Memorandum

Subject: SolSmart Review of Article 31

Review of Article 31: Impact of Proposed Sky Exposure Planes on Solar Access:

Submitted by Nicole Sanches, SolSmart Technical Advisor
September 12, 2017

36 Hemlock Drive, Built 1954, Second Floor Added 2013 (est. based off permit data)

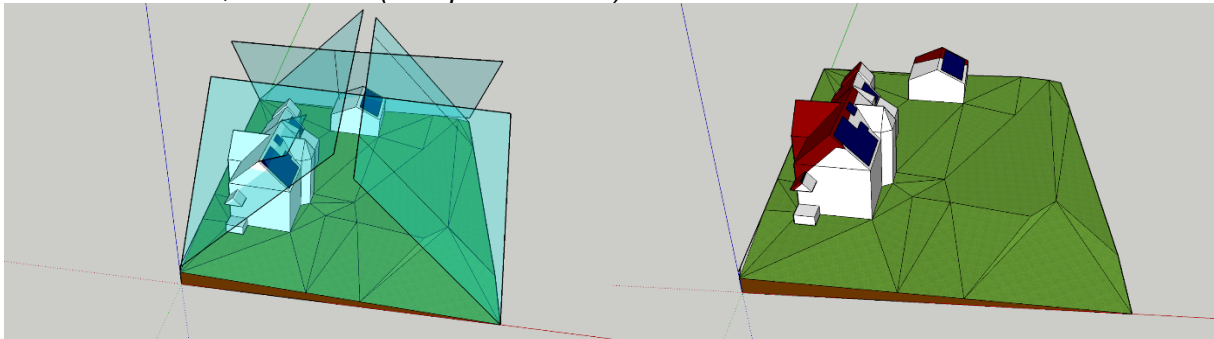
Two pictures are provided for each address studied. The first depicts 1:1 Sky Exposure Planes from each lot line and their relation to existing buildings. The second picture shows the same lot and structure(s); the portion that is shaded red is in violation of one or more of the 1:1 Sky Exposure Planes.
